DART SERVICE INSTRUCTION

TO AMEND INSTALLATION INSTRUCTIONS D350-591 REV. G OR EARLIER
AND
INSTRUCTIONS OF CONTINUED AIRWORTHINESS ICA-D350-591 REV. 2 OR EARLIER
REF CANADIAN STC: SH92-6
REF FAA STC: SH967NE

FIGURE 1: CLAMP DETAIL

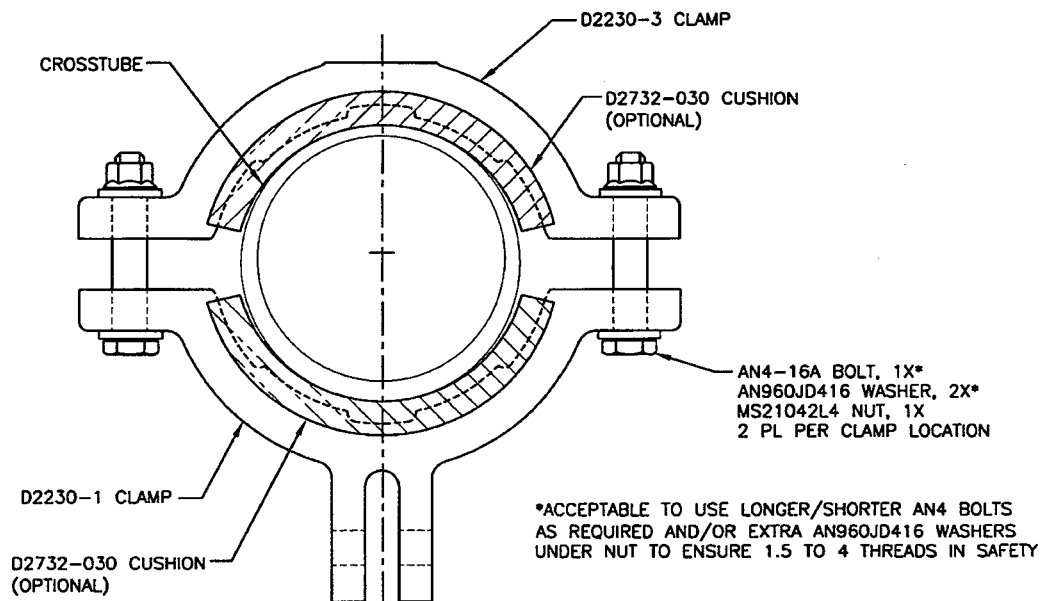
For D350-591-121/-122/-123/-124/-133 steps, customers have the option of installing D2732-030 cushions under the D2230-1/-3 clamps to accommodate varying crosstube diameters and to improve fit. It is also acceptable to use longer or shorter AN4 bolts, and/or extra AN960JD416 washers under the nut to ensure 1.5 to 4 threads in safety. See Figure 1 on sheet 2 of this service instruction for reference.
